Comments on TEPCO Radiological Impact Assessment Report Regarding the Discharge of ALPS Treated Water into the Sea (design stage)

Greenpeace East Asia

Public Submission

16 December 2021

Diagram 1: Land to ocean transfer of radionuclides

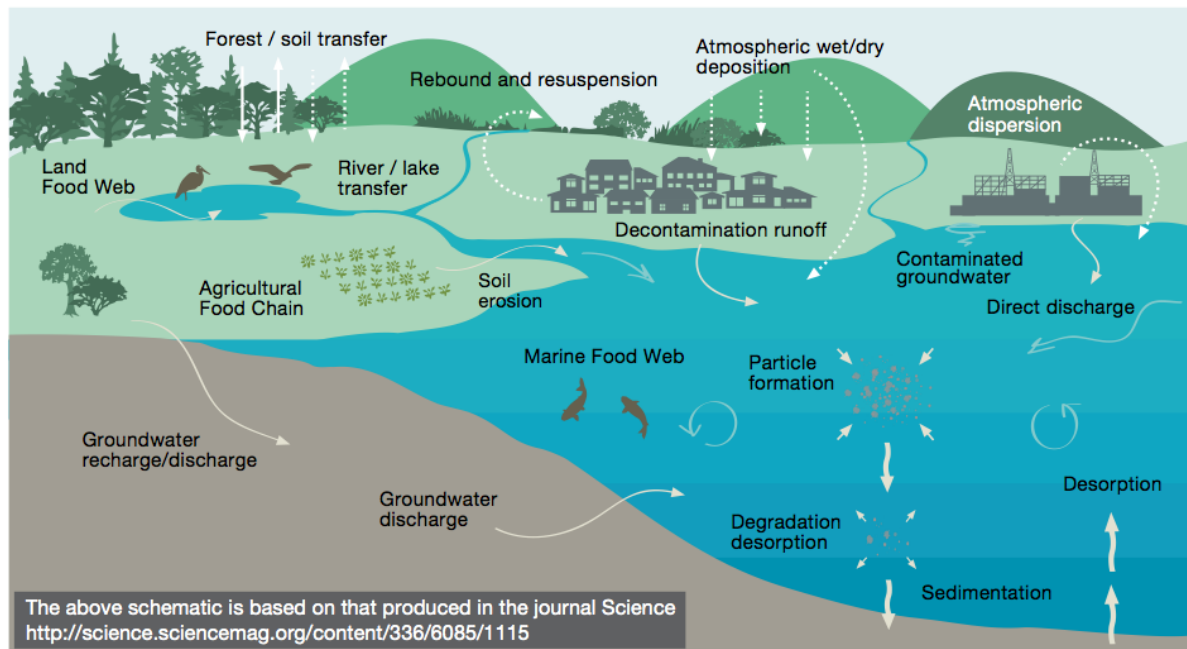
One consequence of down-stream migration of radionuclides is the contamination of estuaries along the Fukushima coast. Due to the high nutrient inputs from rivers, and the fact that estuaries are often sheltered from strong coastal currents, shellfish and marine animals use estuaries for food and as breeding grounds. Although some of the suspended cesium-bearing particulates are deposited along riverbanks,²⁷ a large portion of the mineral-bound radio-cesium is discharged into marine estuaries.²⁸ As demonstrated by C. Chartin, et al. (2013), the river catchments will be a long-term, ongoing source of radiocesium to estuaries and coastal areas. A small percentage of the particulate-bound cesium experiences desorption with rising salinity, when rivers empty to the ocean. Although the percentage of the total inventory is very small, the total amount of newly liberated, dissolved radio-cesium can be quite high due to the large total loads of radioactivity water systems can carry. This can then “easily accumulate in marine biota”.²⁹

TEPCO fails to explain any of these issues in its draft RIA, not least the contamination of estuaries in Fukushima prefecture and other prefectures. The very narrow scope of the draft RIA selected by TEPCO and which only considers impacts within a 10km² area around the end of the proposed discharge point, is clearly not justified.
